Re: Turkey Point Units 3 & 4  
Docket Nos. 50-250 and 50-251  
Proposed Amendment to Facility  
Operating Licenses DPR-31 and DPR-41

This proposal is being submitted to satisfy a commitment made in Reportable Occurrence report 250-77-5 of May 2, 1977, (attached). The proposed change is described below and shown on the accompanying Technical Specification page bearing the date of this letter in the lower right hand corner.

REPORTABLE OCCURRENCE 250-77-5  
TURKEY POINT UNIT 3  
DATE OF OCCURRENCE: APRIL 18, 1977

Fig. 2.1-1. Reactor Core Thermal and Hydraulic Safety Limits, Three Loop Operation

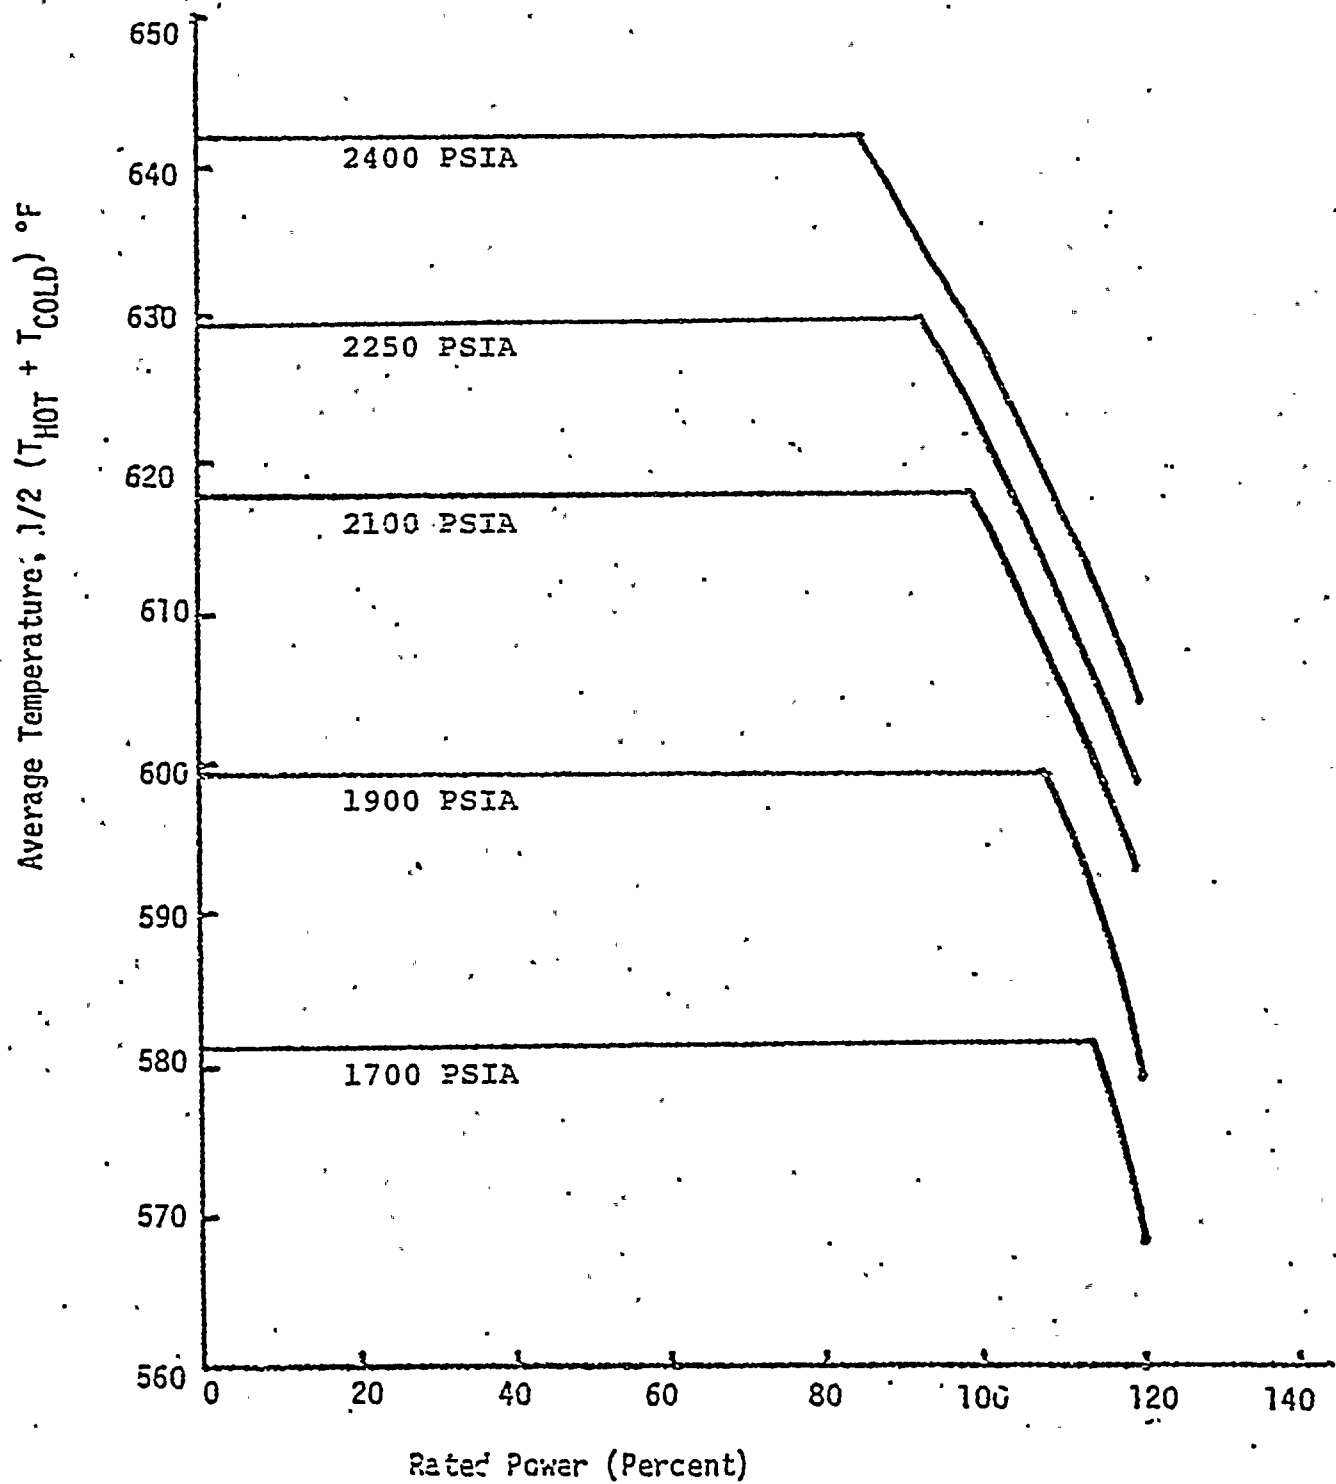
An analysis performed by our NSSS vendor has resulted in a corrected Figure 2.1-1 applicable at the licensed steady state reactor core thermal power output of 2200 Mwt.

012 Discussions with our NSSS vendor have shown that Technical Specification Figure 2.1-1, "Reactor Core Thermal and Hydraulic Safety Limits", requires revision. An analysis performed at 2200 Mwt has yielded a corrected Figure 2.1-1 applicable to both Units 3 and 4. No changes to setpoints, operating limits, or operating practices are required as a result of this correction. Neither unit has ever operated nonconservatively as a

013 This occurrence was caused by a difference between the values of "nominal power" applied to Turkey Point Units 3 and 4 by FPL and the NSSS vendor. The vendor performs analyses based on a nominal power of 2200 Mwt, our licensed steady state reactor core thermal

power output. However, they recently advised us that the specific number being used for analytical work was 2192 Mwt. An analysis performed at 2200 Mwt showed that, in a single case, it would be necessary to make a minor administrative change to a Technical Specification (Figure 2.1-1). Figure 2.1-1 has been adjusted downward the necessary amount (approximately 1.5°F) to compensate for the correction. A proposed Technical Specification amendment will be submitted to the NRC to request a formal change correcting Figure 2.1-1.
